REPORT TO APPLICATION DETERMINATION PANEL

72 Quirk Street Dee Why - Modification of Development Consent DA2013/1264 granted for Alterations and additions to a dwelling house and construction of a swimming pool

APPLICATION FOR MODIFICATION ASSESSMENT REPORT

Application Number:	Mod2014/0207
----------------------------	--------------

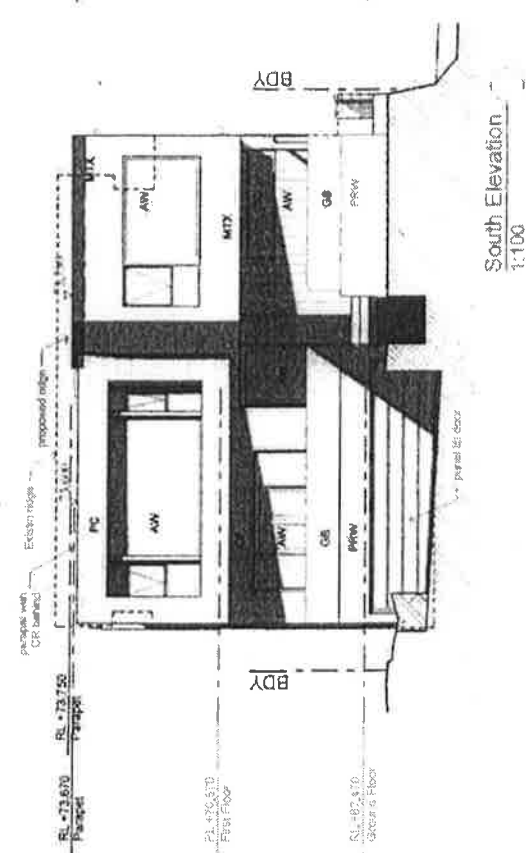
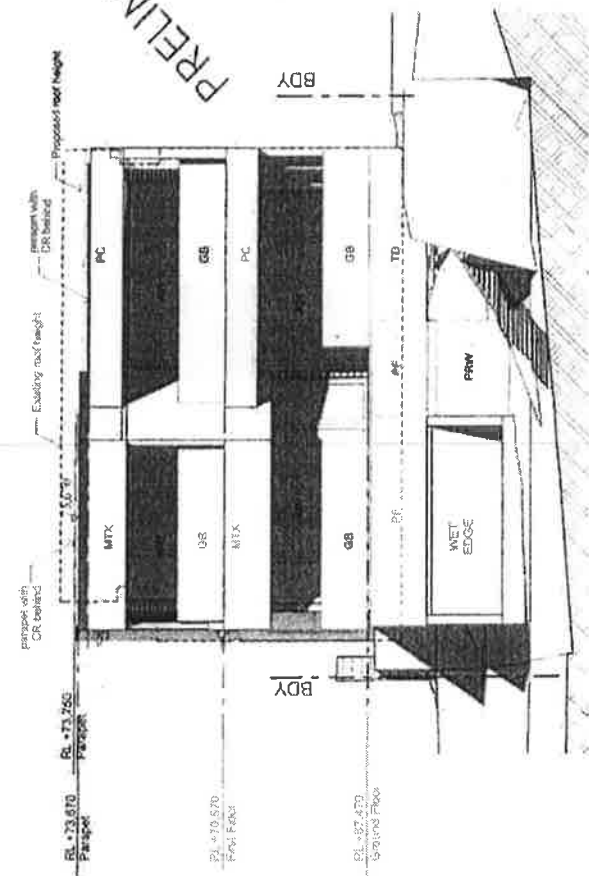
The proposed alteration to the privacy screen on the eastern side of the rear first floor balcony involves extending the privacy screen down to the floor level, replacing the existing solid balustrade shown on the plans. The existing approved balustrade is 1m high, and will not unreasonably reduce the views towards the north and east towards the ocean for the dwelling. Additionally, although the first floor rear balcony is off a living area, it does not form part of the *primary* living area of the dwelling, and the full realisation of these views is not considered to be as valuable as from the ground level primary living area. The removal of the balustrade and replacement with the vertical louvres, will create added privacy impacts in a north eastern direction from a living area, albeit not the primary one, and is considered unnecessary. The objections are supported in this regard, and the extension of the louvres to replace the balustrade is recommended for refusal by condition.

The rear first floor balcony is to retain a solid balustrade on the eastern edge, as shown on the previously approved plan DA11 dated May 09, 2014. The full length privacy screen shown on the proposed modified plan DA11 dated September 12, 2014 is not approved.

The rear first floor balcony is to retain a solid balustrade on the eastern edge, as shown on the previously approved plan DA11 dated May 09, 2014. The full length privacy screen shown on the proposed modified plan DA11 dated September 12, 2014 is not approved.
